**DART Add lock washers to the screws in the
closeout panel behind the driver**

Property name and Top bus number: DART 304500 306500 313000 314000 323000

Engineering Documentation: N15-38589

One area
behind the
driver where
the screws
are located.

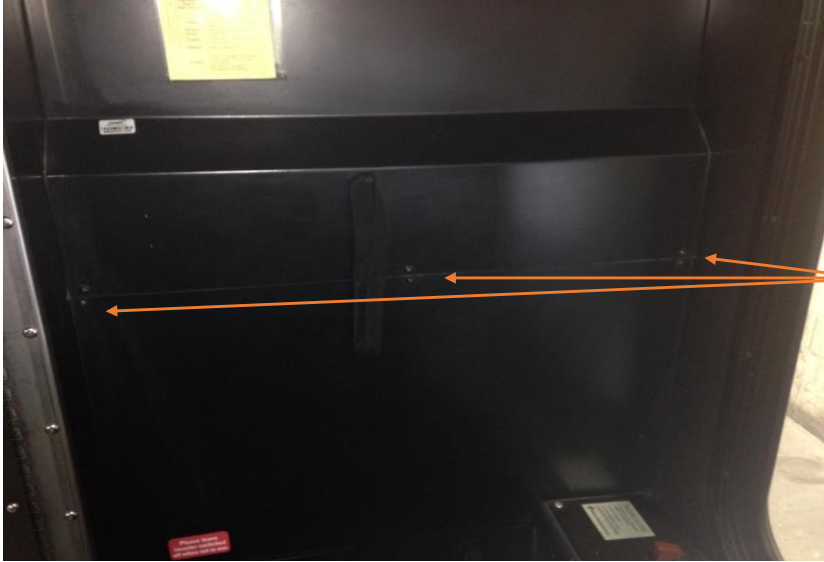
Issue: The screws in the closeout panel behind the driver are coming loose.

Reason/ cause: There is no locking mechanism to hold them in place.

Solution: Add a lock washer.

1. Turn off main battery disconnect switch(es)
2. Located behind the driver there are closeout panels with Phillips screws.
3. Remove the screws and add a lock washer and put the screws back.
4. Repeat this process on all the screws in the closeout panels behind the driver.
